May 29, 2019
Subject: Bridge Rail & Post Replacement
State WIN: 024246.00
Location: **Waterville & Benton**
Amendment No. 3

BRIDGE RAIL AND POST REPLACEMENT
KENNEBEC COUNTY

TRAFTON ROAD BRIDGE (BR#5812) &
BELLSQUEEZE ROAD BRIDGE (BR#5994)
OVER
INTERSTATE 95
WR#35374
WIN 24246.00

Revised Plans
05/28/2019

DETAILS and PARTS SCHEDULES

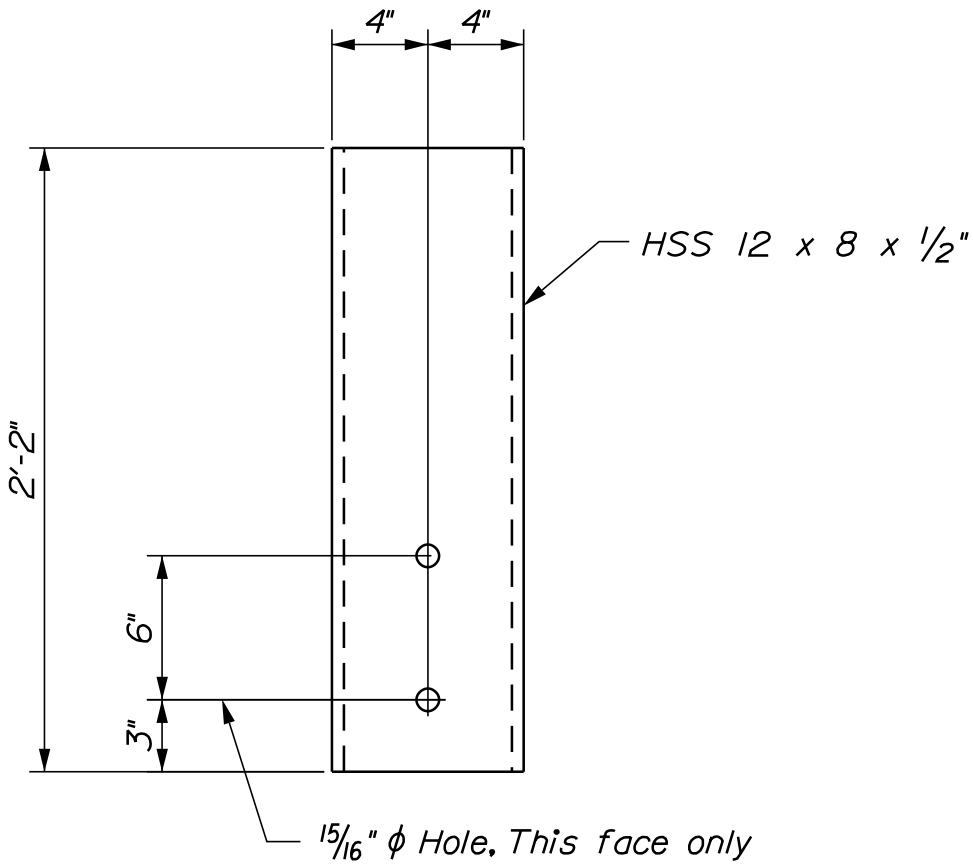
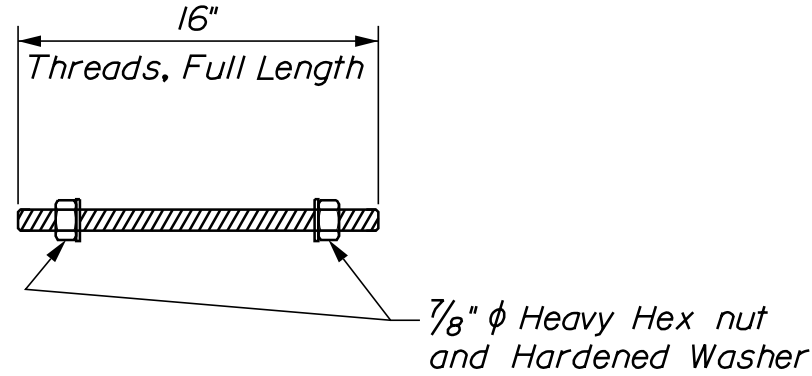
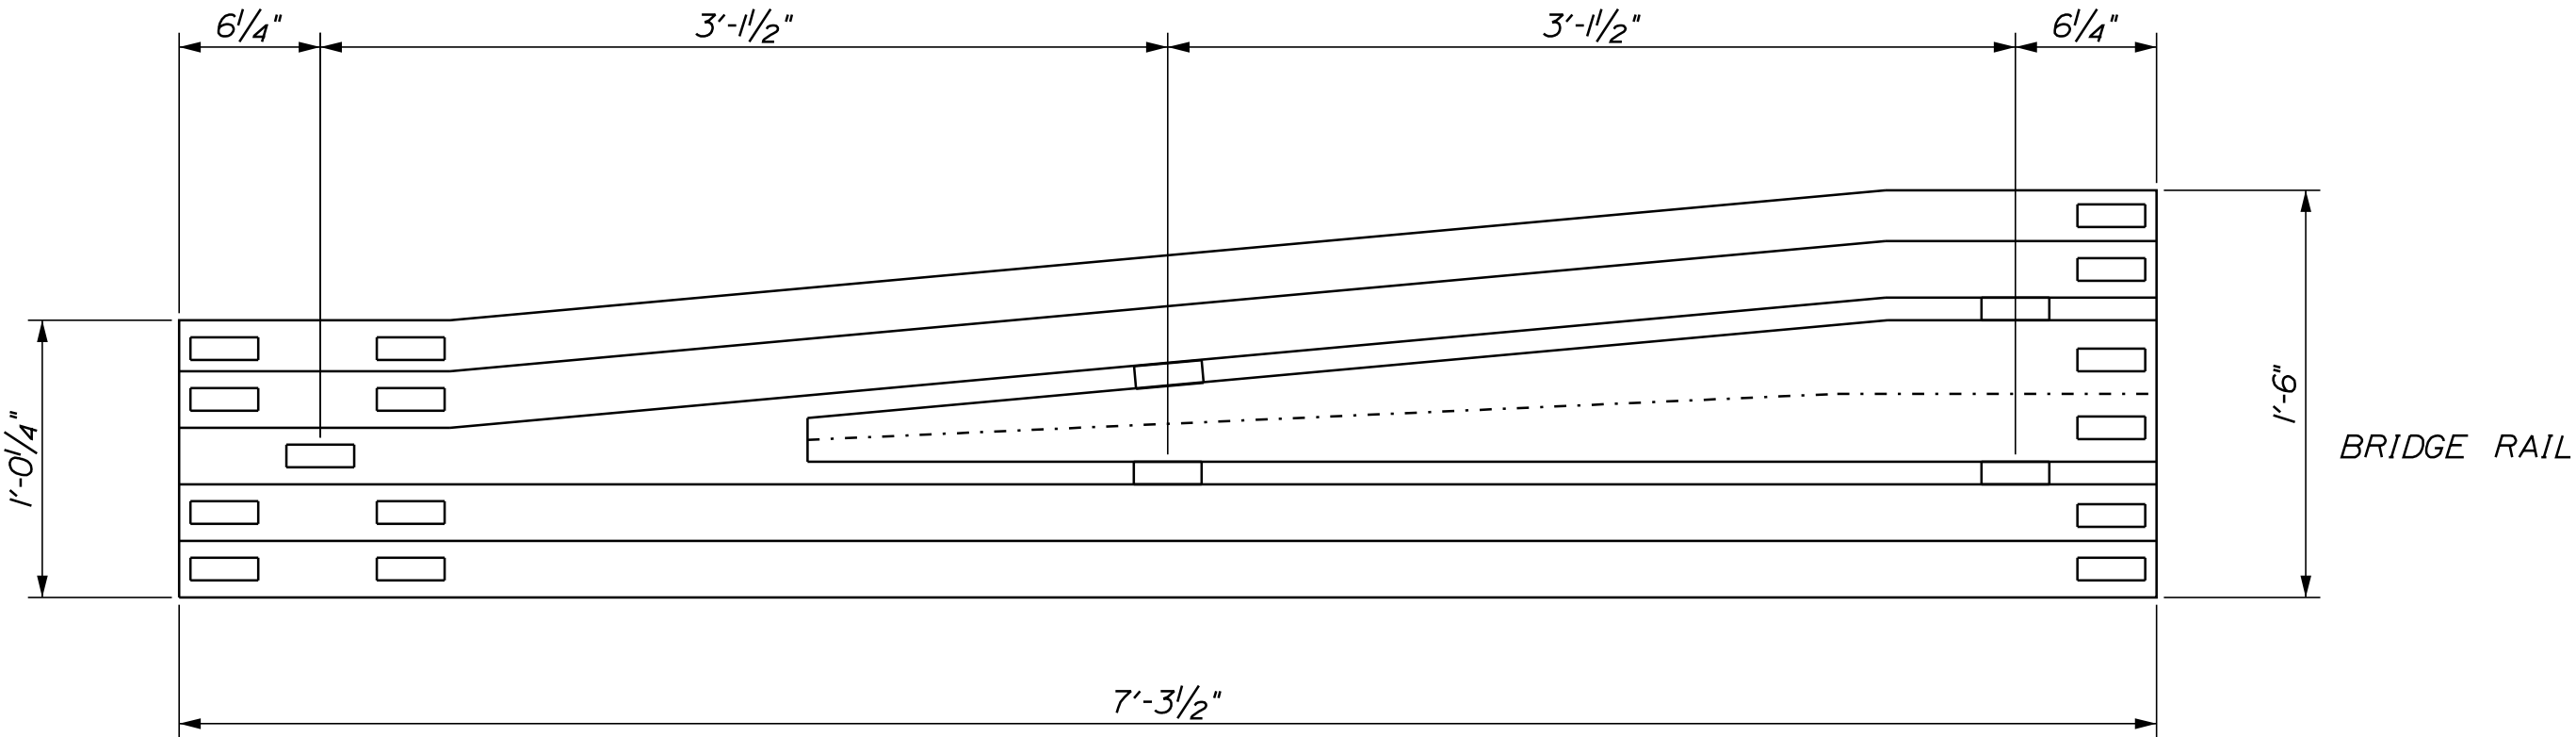
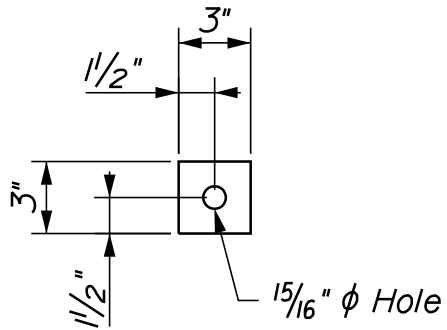
Question: The Department included a parts schedule for each bridge. Waterville has 114 HSS 12 X 8 Guardrail Brackets and Benton has 96, for a total of 200 Brackets. I believe this must be incorrect, plans call out for 1,754 LF of Thrie Beam with guardrail brackets spaced at a maximum of 6.25'.

PROJ. MANAGER	Cy Adams	BY	DATE
DESIGN-DETAILED	G. Libby	G. Libby	MAY 2019
CHECKED-REVIEWED	J. Velleux	J. Velleux	
DESIGNS DETAILLED			
REVISIONS 1	Quantities Revised & Sheet Added		05/28/19
REVISIONS 2			
REVISIONS 3			
REVISIONS 4			
FIELD CHANGES			
SIGNATURE			
P.E. NUMBER			
DATE

Response: See the attached, revised plans for corrected quantities.

PARTS SCHEDULE for BR*5812 (WATERVILLE)			
QUANTITY	DESCRIPTION	LENGTH	REMARKS
124	HSS 12 x 8 x 1/2"	2'-2"	Guardrail Brackets - ASTM A500, Galvanized
250	7/8" Threaded Rod	1'-4"	Thread, Full Length - ASTM A449, Galvanized
500	7/8" Heavy Hex nut	NA	ASTM A563, Galvanized
500	7/8" Hardened Washer	NA	ASTM F436, Galvanized
250	3" x 3" x 1/4" Plate Washer	NA	ASTM A36, Galvanized
250	5/8" Button Head Bolts	2"	1 - Hex Nut (A563) and 1 - Hardened Washer (A436), Galvanized

PARTS SCHEDULE for BR*5994 (BENTON)			
QUANTITY	DESCRIPTION	LENGTH	REMARKS
168	HSS 12 x 8 x 1/2"	2'-2"	Guardrail Brackets - ASTM A500, Galvanized
340	7/8" Threaded Rod	1'-4"	Thread, Full Length - ASTM A449, Galvanized
680	7/8" Heavy Hex nut	NA	ASTM A563, Galvanized
680	7/8" Hardened Washer	NA	ASTM F436, Galvanized
340	3" x 3" x 1/4" Plate Washer	NA	ASTM A36, Galvanized
8	3/4" Button Head Bolts	1 3/4"	For Expansion Joint; 1 - Hex Nut (A563) and 1 - Hardened Washer (A436), Galvanized
340	5/8" Button Head Bolts	2"	1 - Hex Nut (A563) and 1 - Hardened Washer (A436), Galvanized
